SECTION 009113 – ADDENDUM THREE

- A. Project Name: 22062 Picayune Multipurpose and Band Hall Renovation
- B. Owner: Picayune School District, 706 Goodyear Blvd., Picayune, MS 39466
- C. Architect: Dale | Bailey, an Association, 188 E. Capitol Street, Suite 250, Jackson, Mississippi, 39201
- D. Architect Project Number: 22062
- E. Date of Addendum Three: 10 July 2023

1 PROPOSED MULTIPURPOSE CIVIL SITE PLAN
SCALE: 1" = 10'-0"

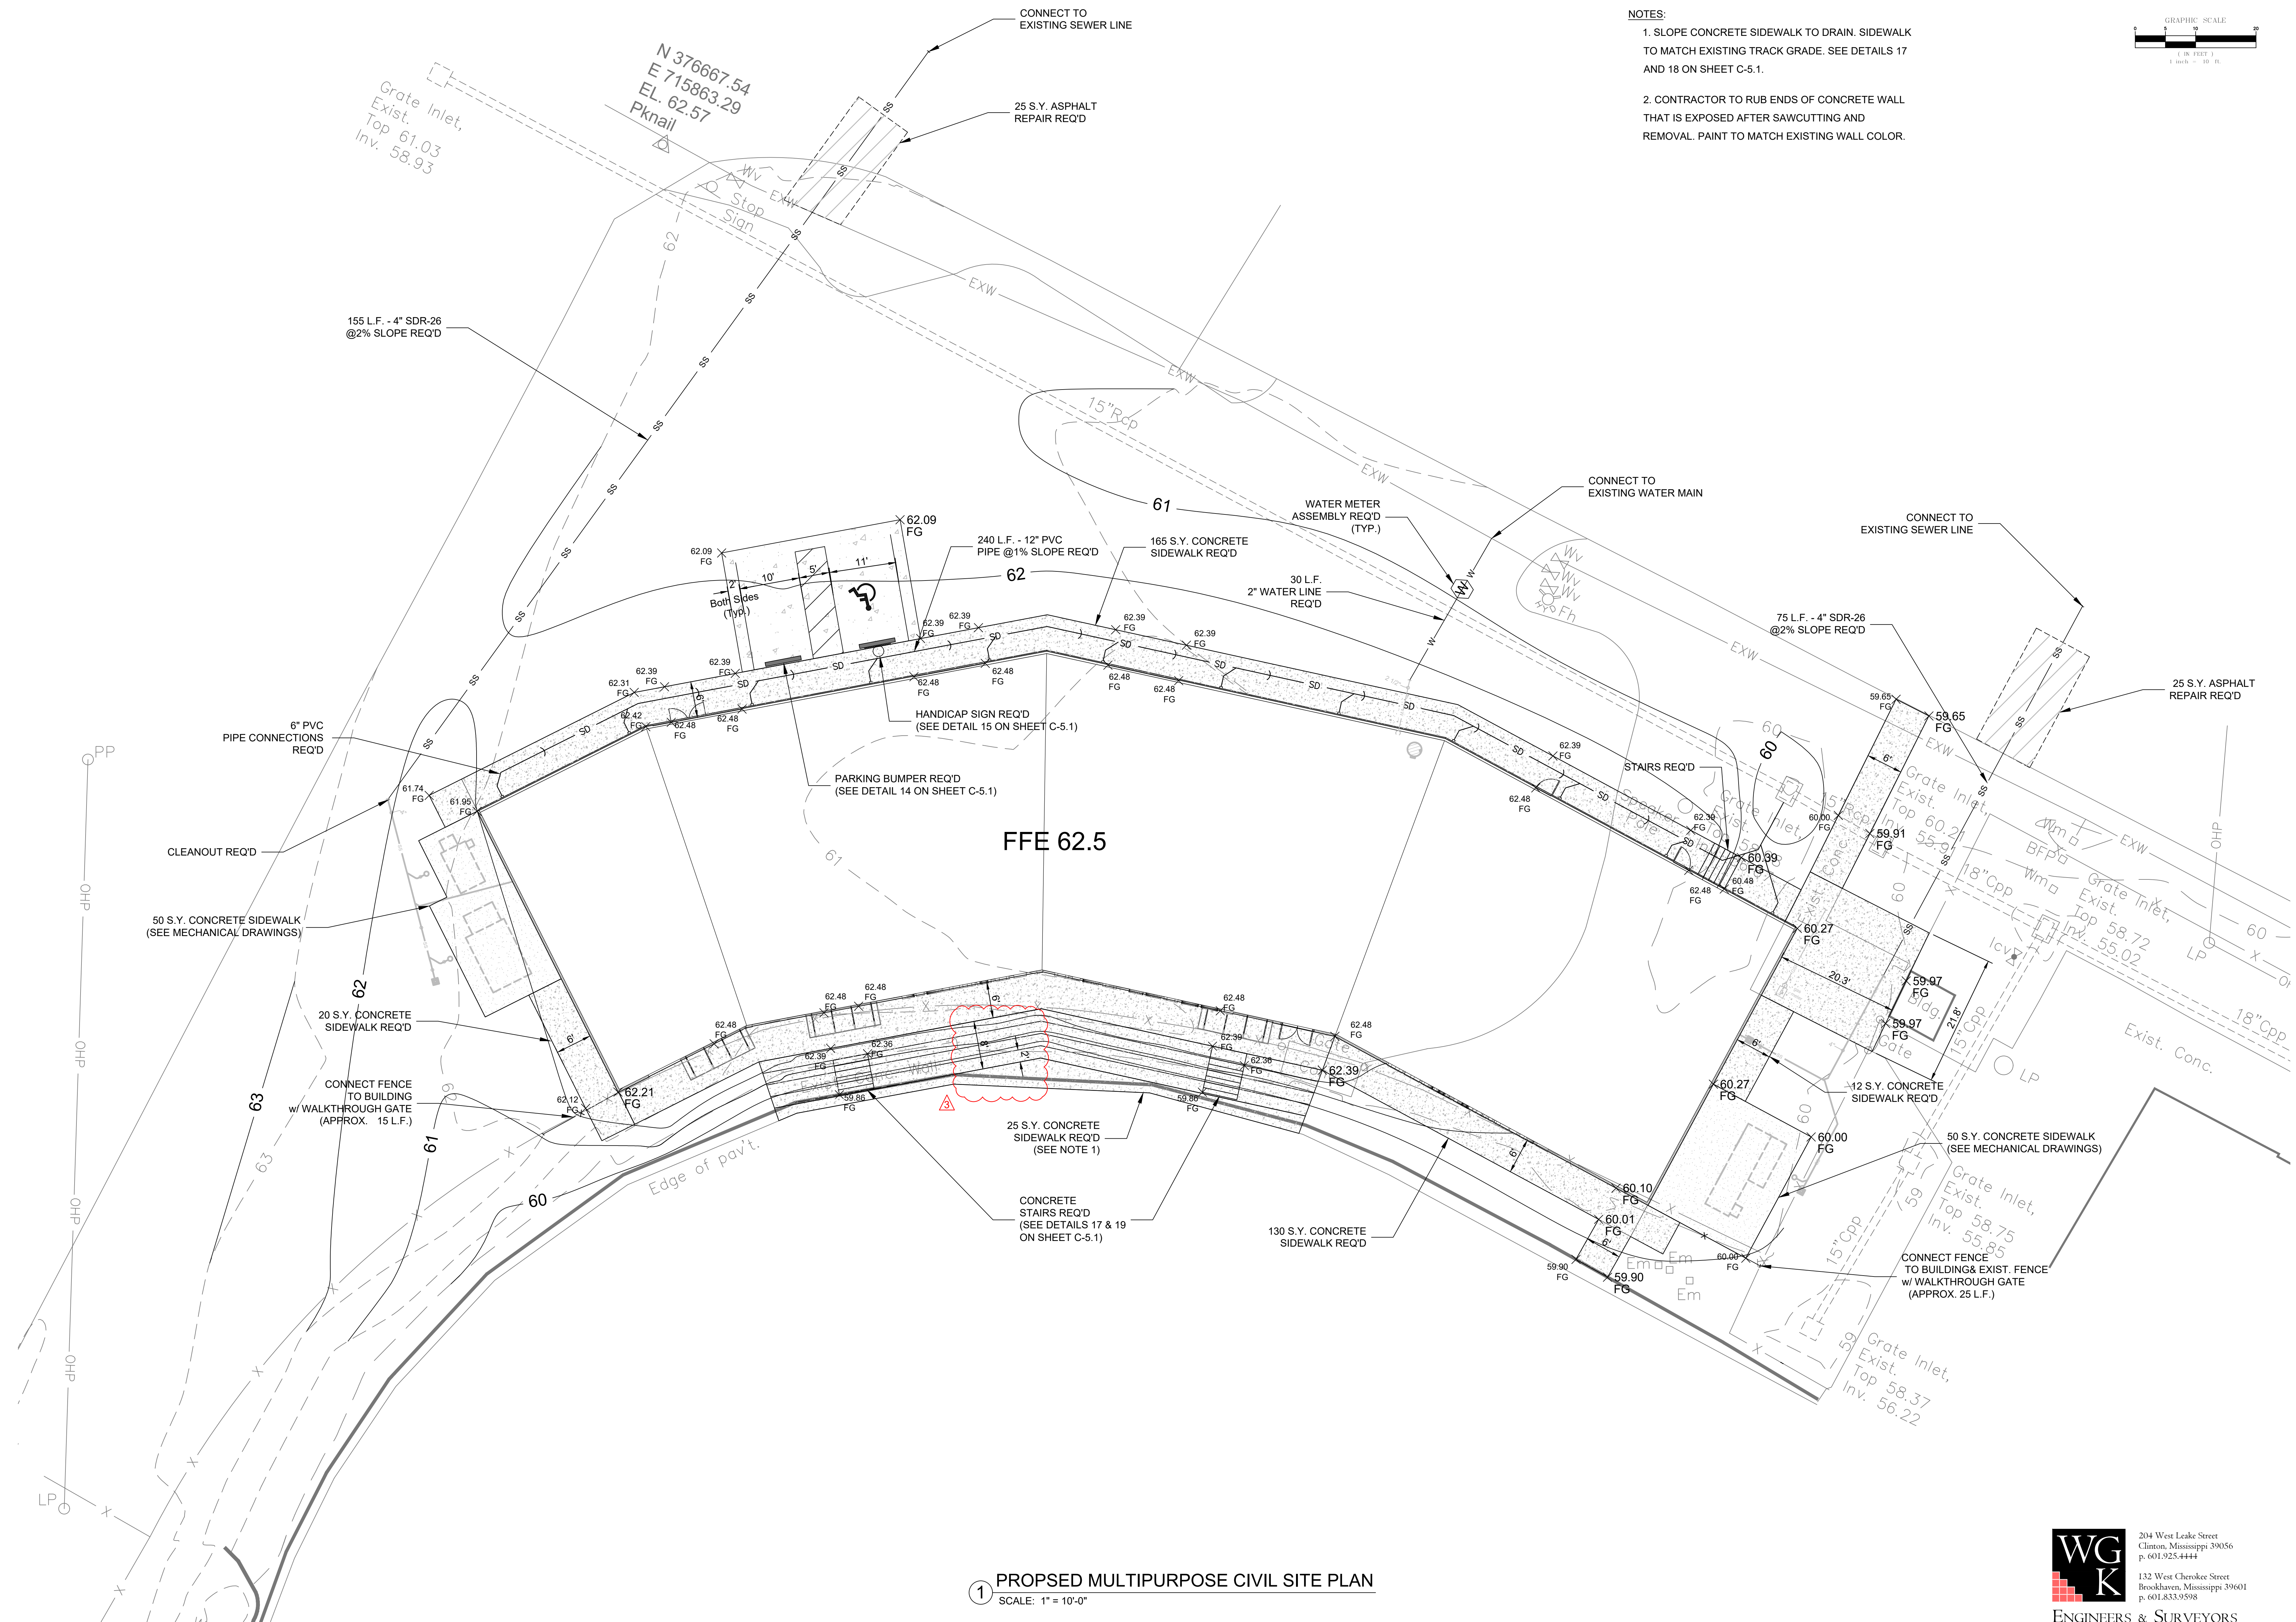
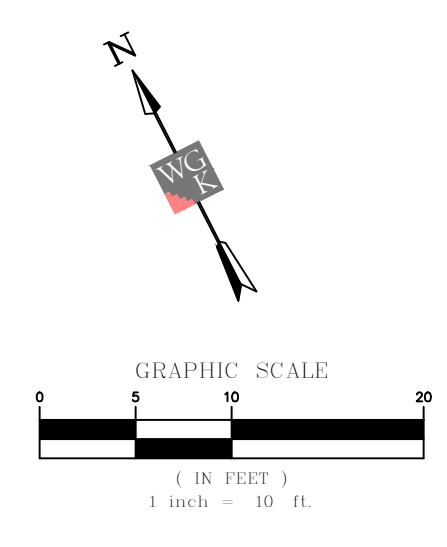
- A. Sheet C-4.0 – Site Plan (Re-Issued). Delete this sheet in its entirety and replace it with the attached. Added additional dimensions.
- B. Sheet C-4.1 – Site Plan (Re-Issued). Delete this sheet in its entirety and replace it with the attached. Added additional dimensions in various locations. Removed multileaders in two locations.

17 STAIRS DETAIL
N.T.S.

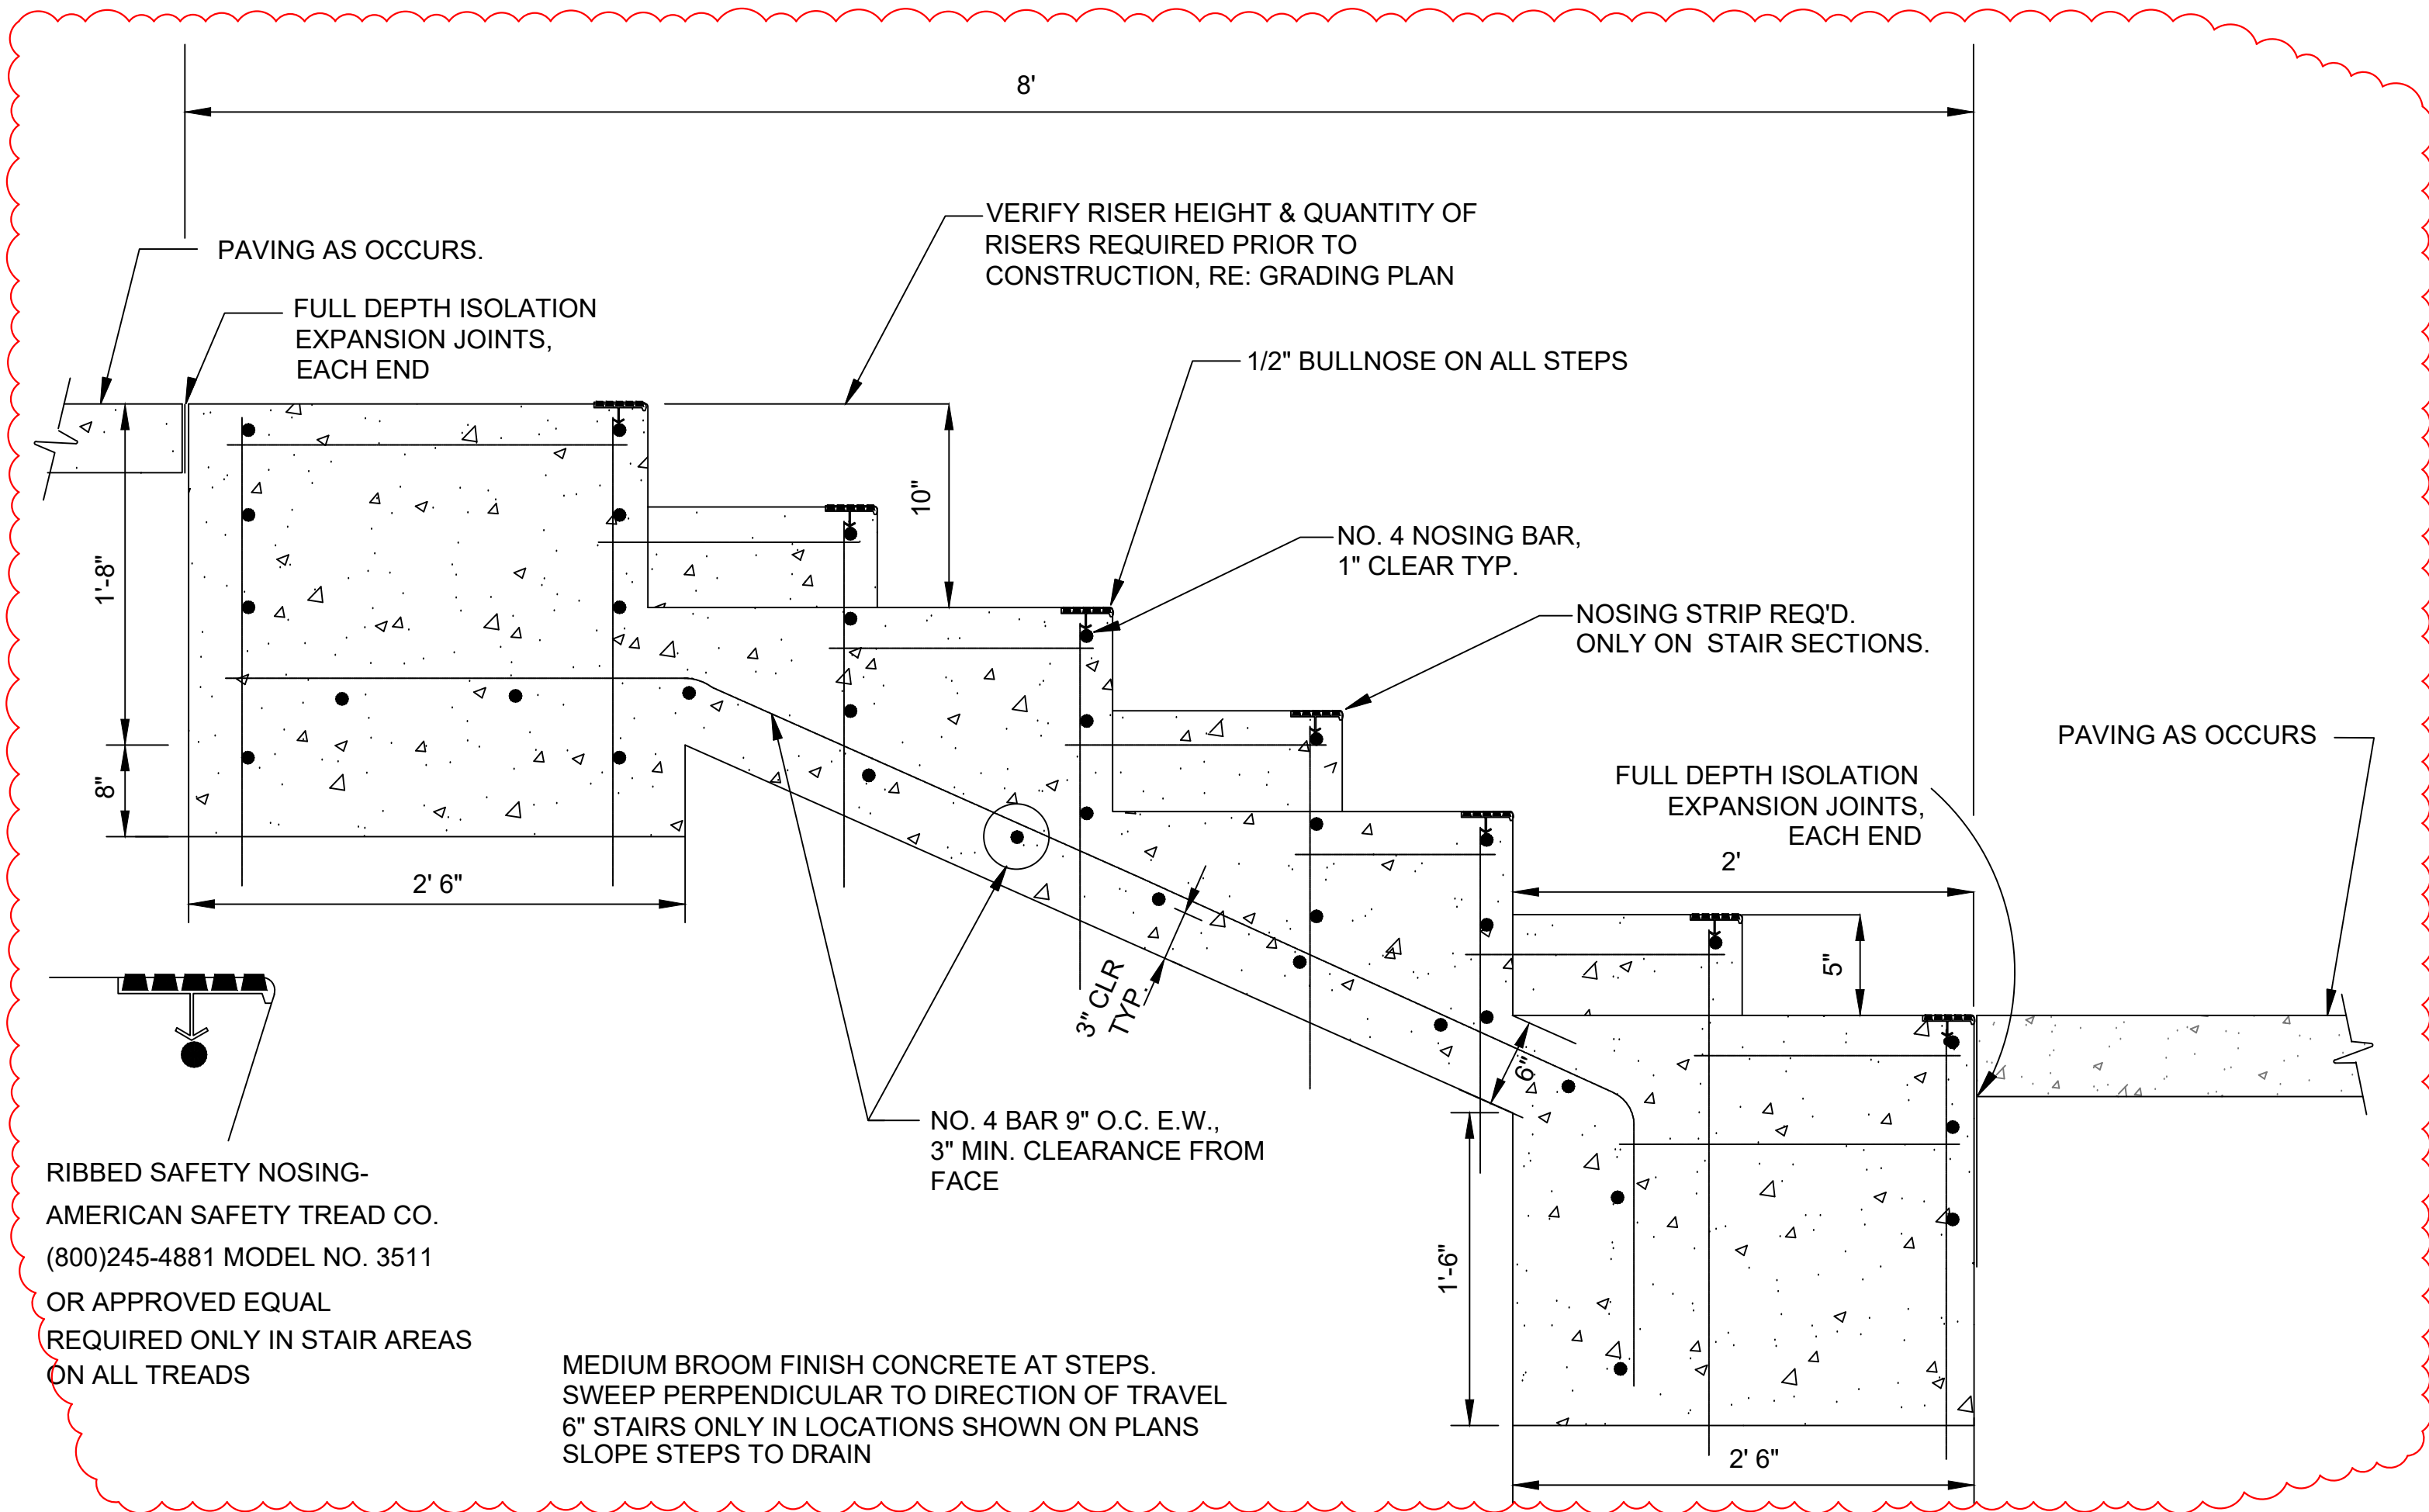
- C. Sheet C-5.1 – Construction Details (Re-Issued). Delete this sheet in its entirety and replace it with the attached. Made revisions to Details 17 and 19.

1 ONE-LINE DIAGRAM - NEW MULTIPURPOSE BUILDING
Scale: NONE

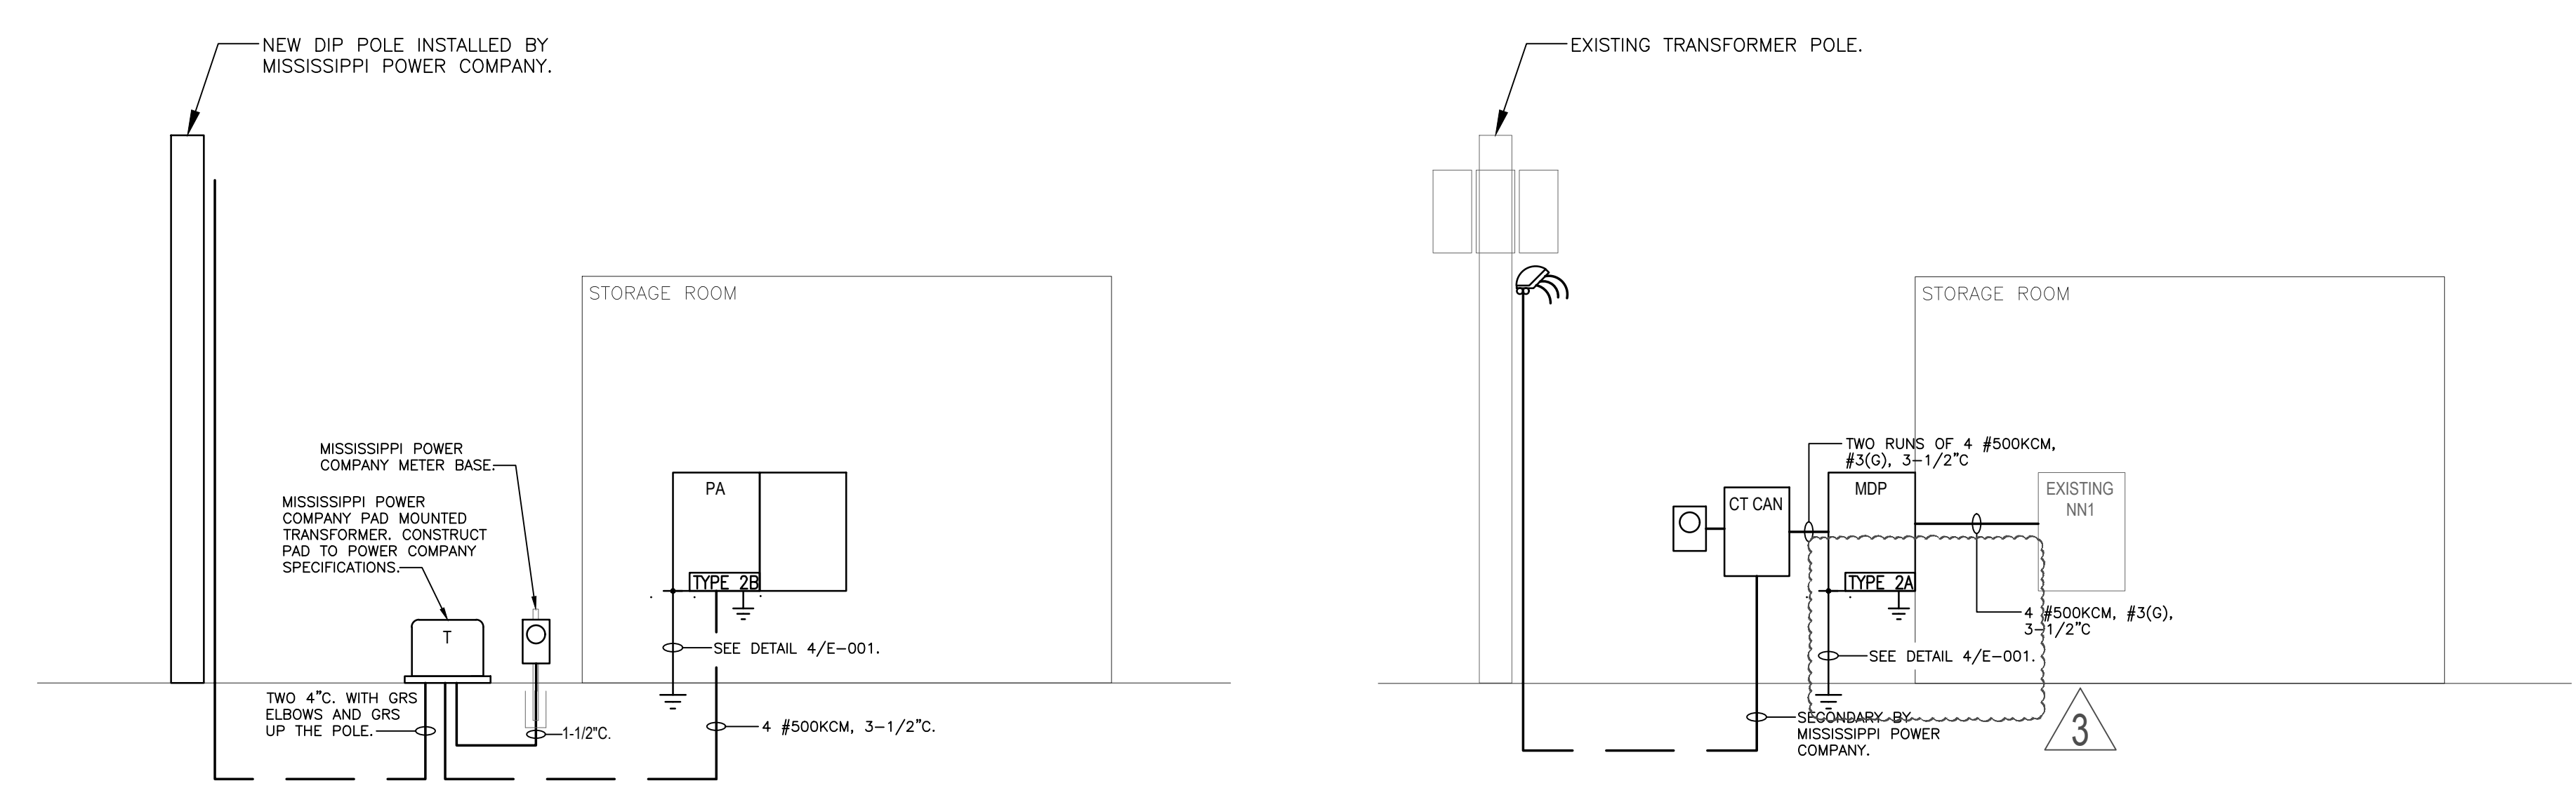
- G. Sheet S-203 – Foundation Sections and Details (Re-Issued). Delete this sheet in its entirety and replace it with the attached. Updated drawings.
- H. Sheet E-000 – Electrical Legend (Re-Issued). Delete this sheet in its entirety and replace it with the attached. Added a surge protection device and ground to new panel 'MDP'.

4 GROUNDING DETAIL
E-001 Scale: NONE

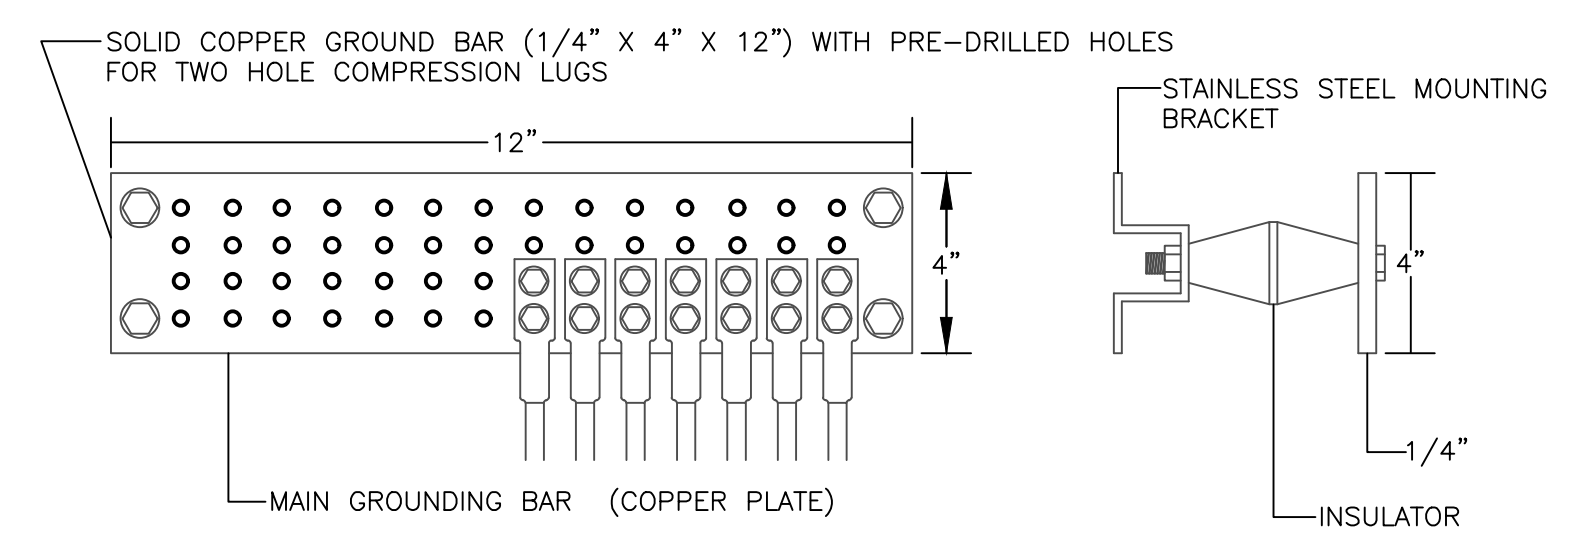
- I. Sheet E-001 – Electrical Details (Re-Issued). Delete this sheet in its entirety and replace it with the attached. Updated ground detail.
- J. Sheet E-003 – Panel Schedules (Re-Issued). Delete this sheet in its entirety and replace it with the attached. Added 30/3 breaker in panel 'MDP' for surge protection device.
